REVIEW CHECKLIST

Floodway Substantial Improvement

Washington State Department of Ecology

Address 41649 North Shore Lane, Concrete
Year of construction 1967
Type of foundation Concrete, at grade?
Observed flood damages 2.08% damage in 2021, 75% damage in 2025

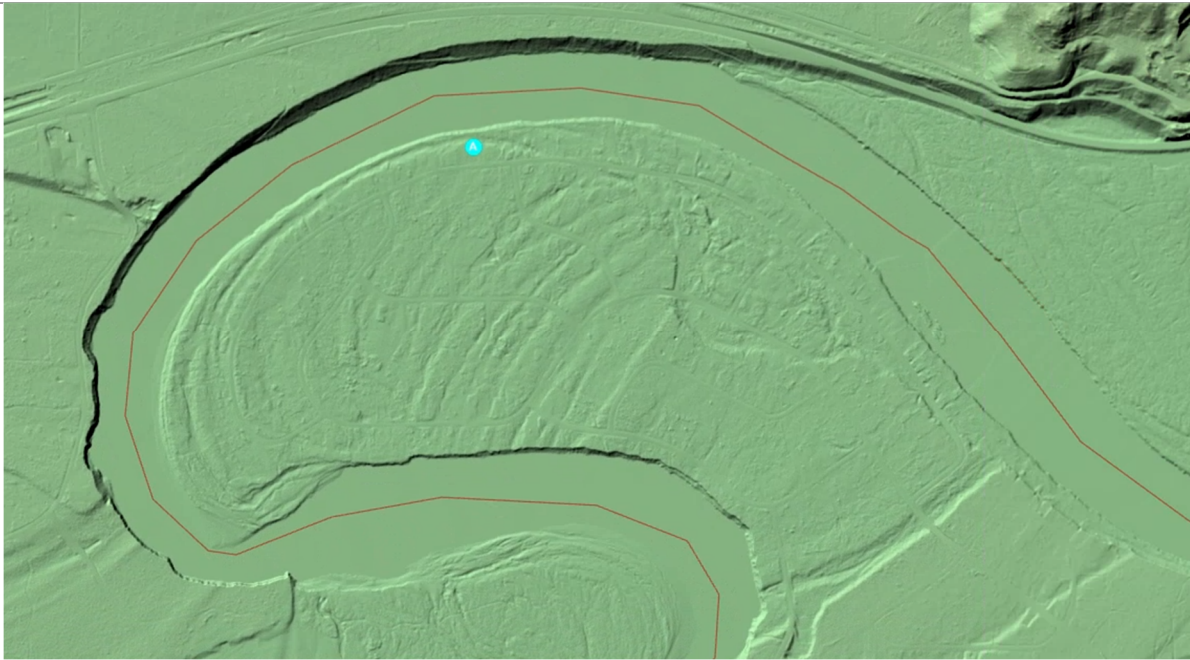
Scour was not observed during the 2025 flood event per Skagit County communication. Ecology could not locate a channel migration zone delineation. However, the site and vicinity have clear evidence of active channel migration as shown in the lidar digital elevation model below (obtained from Washington State Department of Natural Resources). The subject property is located at the blue dot.

Flood depth exceeds 3 feet and velocity exceeds 3 feet/second. Topographic data shows evidence of active channel migration.
